Property Made Submission – Material Change of Use (Development Permit) – Warehouse proposed over land at 607 Lytton Road, Murarrie (Lot 5000 on SP337840)
Council Application No - A006608896
Energex Reference - ECM 20363100 - 43135637

Grounds of Submission

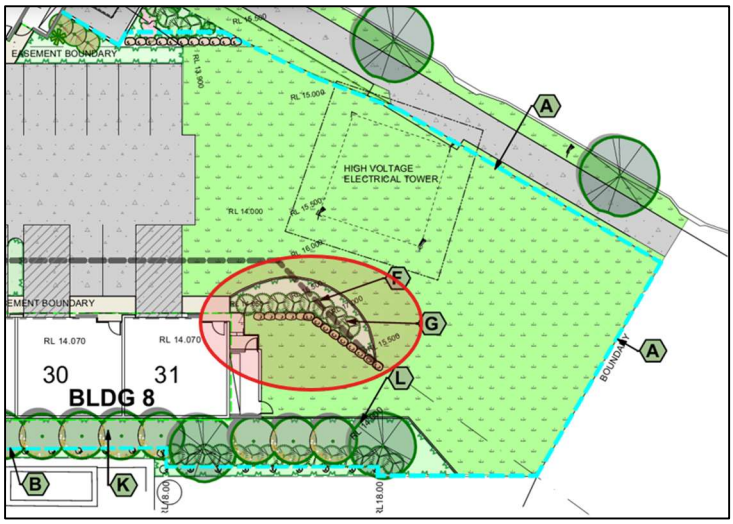
As part of its referral agency assessment, Energex issued an Information Request on 29 October 2024 seeking a conductor line assessment from the applicant to demonstrate that the proposed buildings and structures would comply with the applicable statutory clearance requirements under the *Electrical Safety Regulation 2026*. This request was made following Energex's preliminary assessment, which indicated that the proposed development was likely to result in a clearance-to-structure conflict under maximum operating conditions of the powerline.

To date, Energex's Town Planning Department has not received a completed conductor line assessment or any other technical information from the applicant demonstrating that the location and design of the proposed buildings will achieve compliance with the relevant statutory clearance requirements. Energex subsequently reiterated this requirement to the applicant in June 2026; however, no formal response has been provided.

Accordingly, Energex submits that Council should require the applicant to undertake and provide a conductor line assessment, based on the maximum operating conditions of the existing 110kV powerline, to demonstrate that the proposed development achieves compliance with all applicable statutory electrical safety clearances under the *Electrical Safety Regulation 2026*.

It is noted that the absence of building encroachments within the easement area does not, of itself, demonstrate compliance with the clearance requirements of the *Electrical Safety Regulation 2026*. The applicant must provide the necessary technical assessment to verify that the proposed development can operate safely in proximity to the existing electricity infrastructure.
